Number	Description
1	Revised Table of Contents; Revised NTB Nos. 4869 & 4872; Added NTB No. 4873; Revised Bid Items; Revised or Added Plan Sheet Nos. 8001-8003, 8005, 8024 & 8026; Amendment EBSx Download Required.

PROJECT: BR-0042-01(010)/100573301 - Kemper

ADDENDUM

STATE	PROJECT NO.
MISS.	BR-0042-01(010)

MISSISSIPPI DEPARTMENT OF TRANSPORTATION
BRIDGE AT STA. 222+83.88
GENERAL NOTES & ESTIMATED QUANTITIES

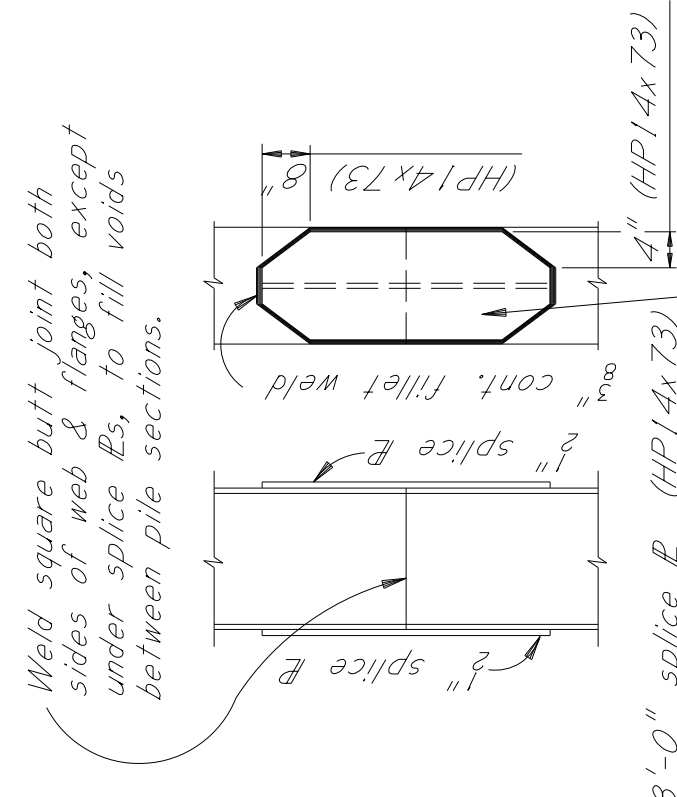
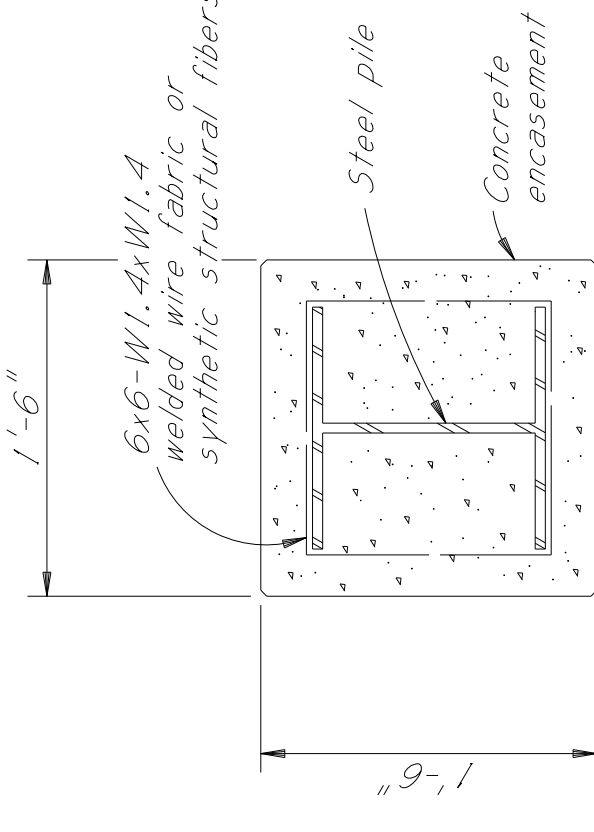
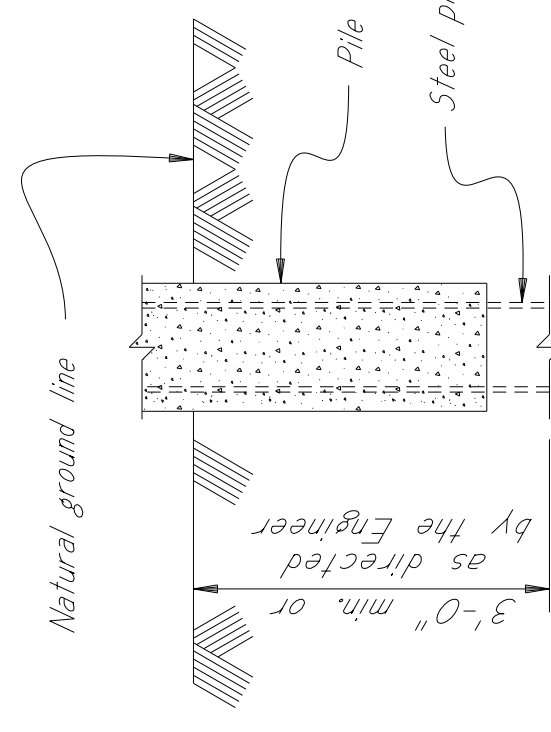
Test piles shall be driven with an approved impact hammer as a location pile at the location shown in the PDA TEST PILE SCHEDULE and will be paid for as test piles only.

The first PDA test pile driven shall be an indicator PDA test pile as shown on the Foundation Plan. The indicator PDA test pile shall be driven continuously using an approved impact hammer, until the PDA indicator test pile is complete.

The PDA monitored indicator test pile will be out-of-position pile driven with mandatory restrikes and PDA results analyzed prior to driving any PDA test piles. Based on the results of the PDA indicator test pile, the plan lengths of the PDA test piles may change. The PDA indicator test pile is complete.

Indicator test piles shall be 25'-0" from proposed centerline at Bents No. 2 & 4. See sheet no. A3 for location of test piles.

DATE	REVISION	BY
5/10/23	Indicator Test Pile Notes & Quantities	JWF

MISSISSIPPI DEPARTMENT OF TRANSPORTATION
 BRIDGE AT STA. 222+83.88
 SR 397 ACROSS NANAWAYA CREEK TRIBUTARY FOUNDATION PLAN

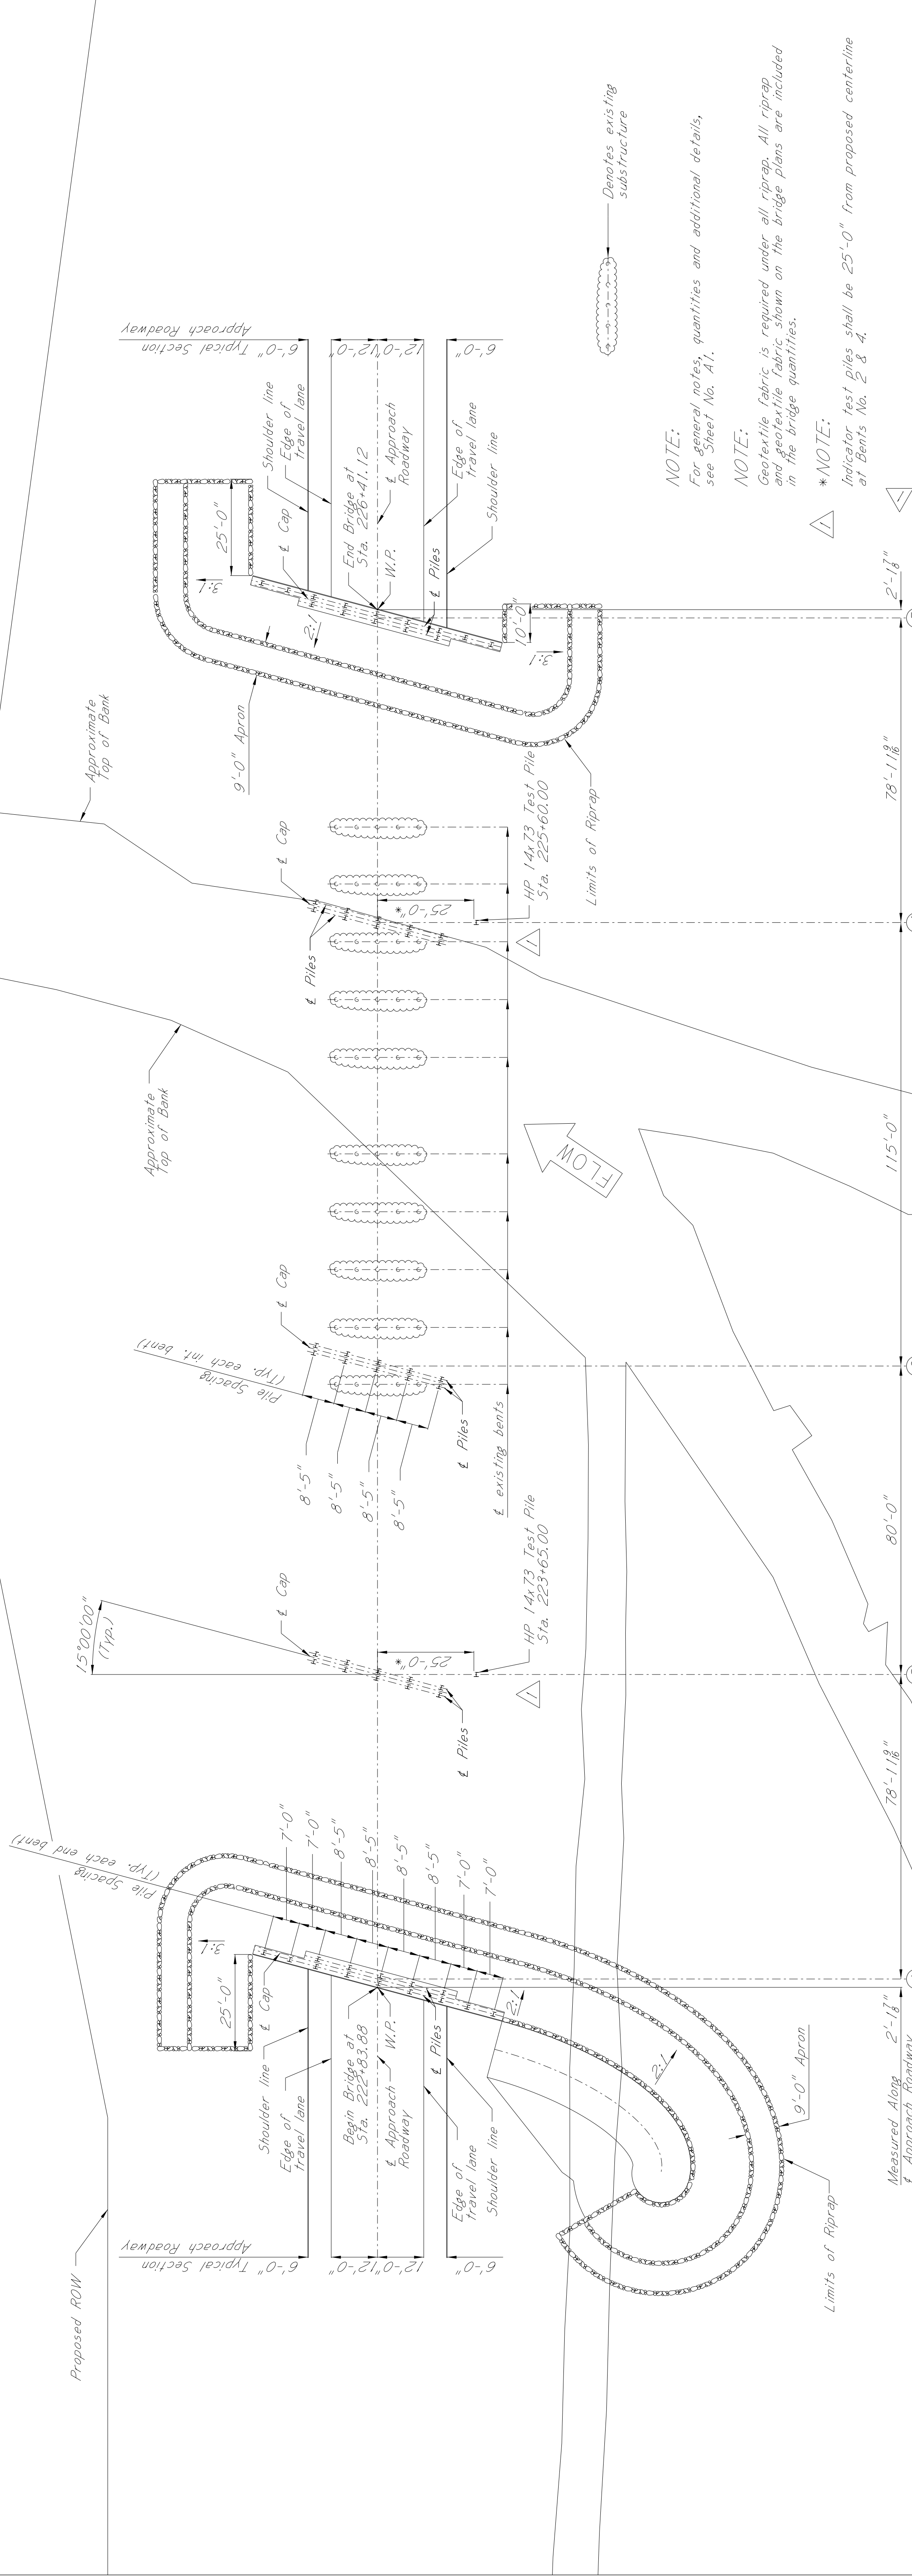
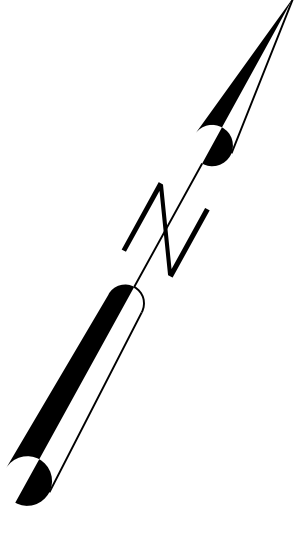
***NOTE:**
Indicator test piles shall be 25'-0" from proposed centerline at Bents No. 2 & 4.

DATE	BY	REVISION
5/10/23	JWF	Out-of-Place Test Piles, Project Number

MISSISSIPPI DEPARTMENT OF TRANSPORTATION
 BRIDGE AT STA. 248+58.92
 GENERAL NOTES &
 ESTIMATED QUANTITIES

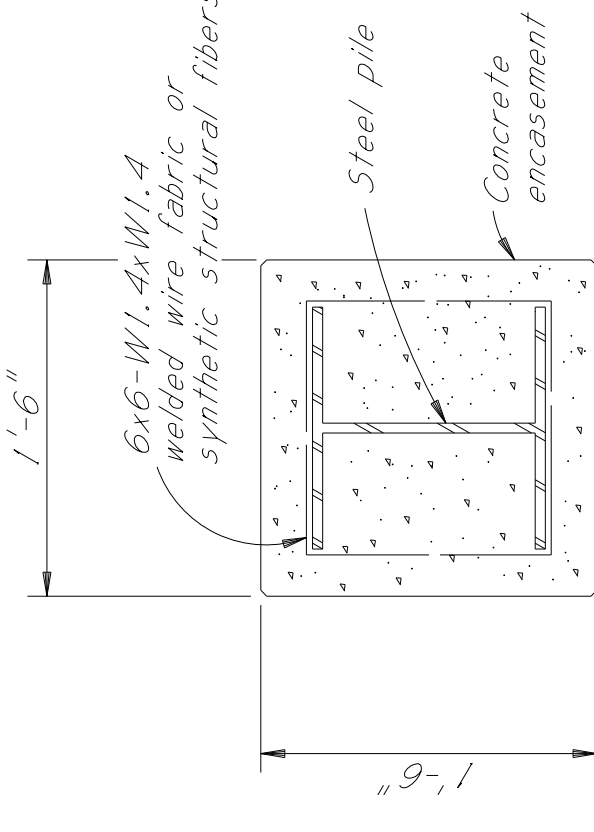
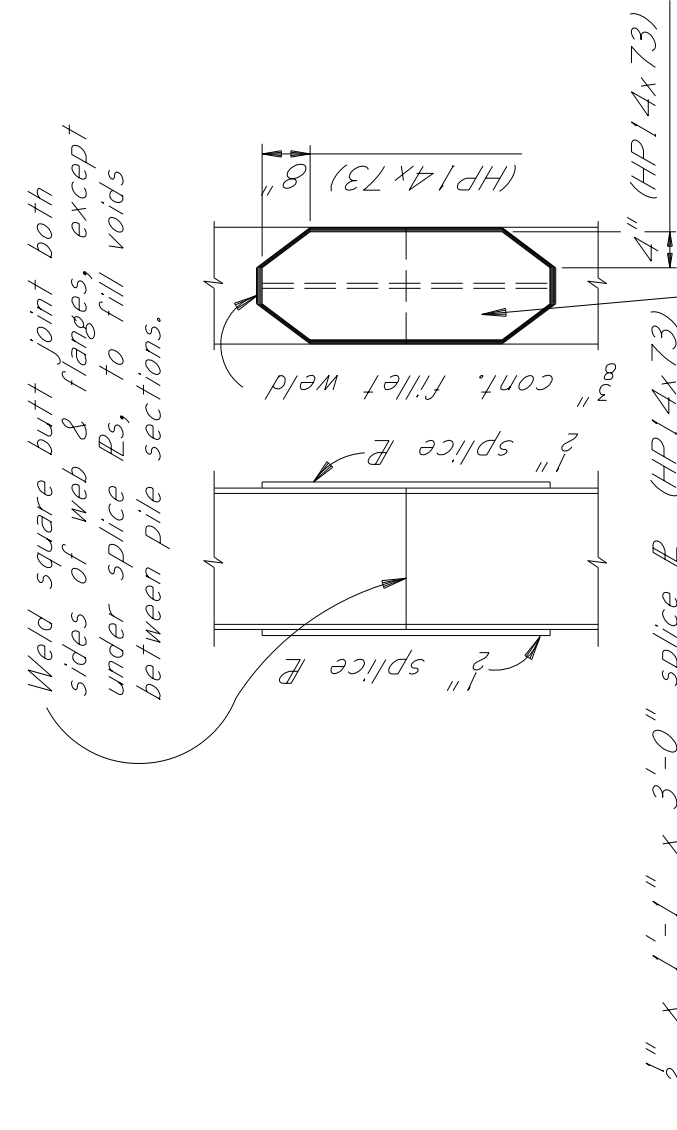
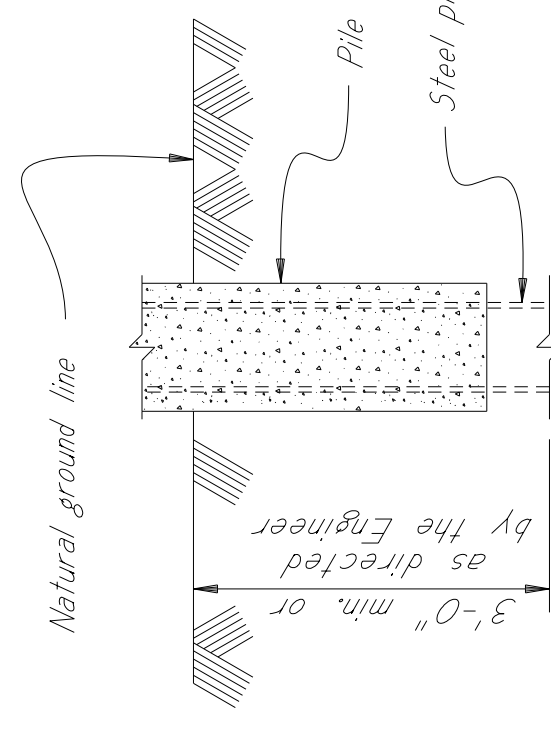
NOTE:
 Indicator test pile shall be 25'-0" from proposed centerline at Bent No. 2. See sheet no. B3 for location of test pile.

DATE	REVISION	BY
5/10/23		JMF

MISSISSIPPI DEPARTMENT OF TRANSPORTATION
BRIDGE AT STA. 248+58.92
SR 397 ACROSS UNNAMED CREEK
FOUNDATION PLAN

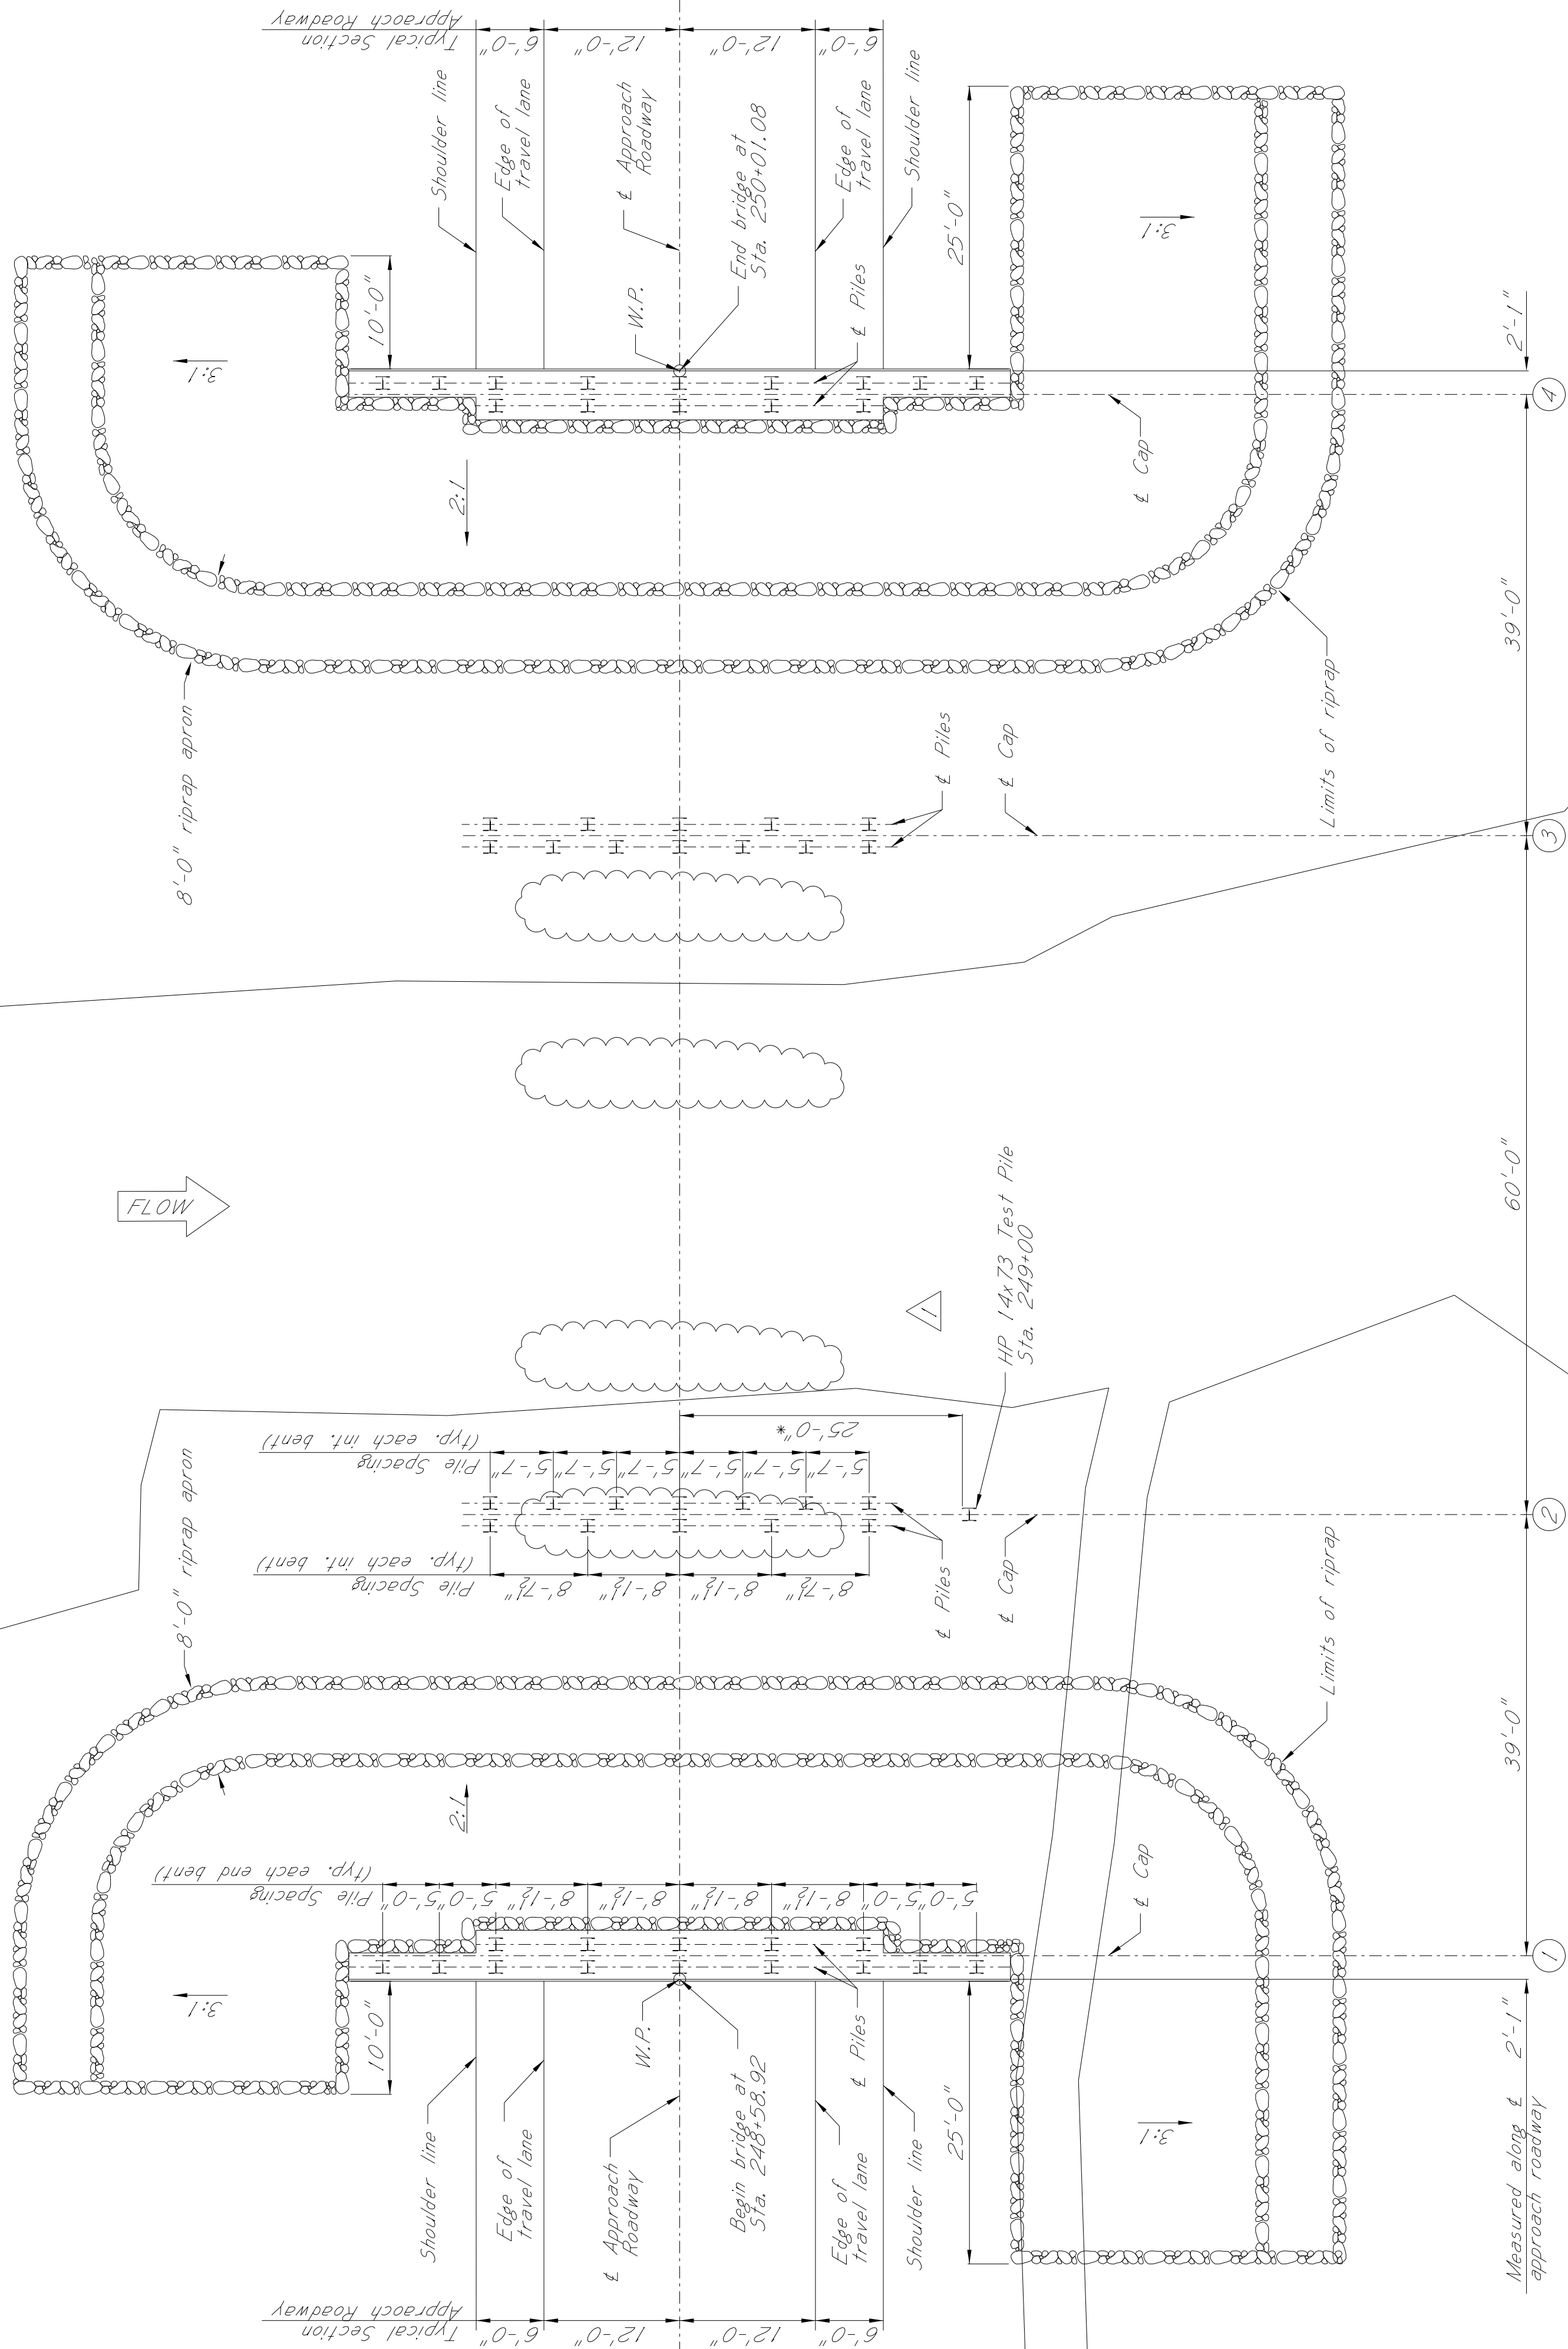
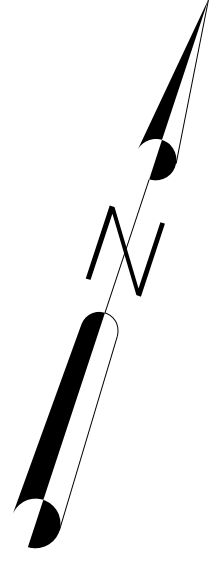
***NOTE:**
Indicator test pile shall be 25'-0" from proposed centerline at Bent No. 2.

DATE	REVISION	BY
5/10/23	Out-of-Place Test Pile Project Number	JWF
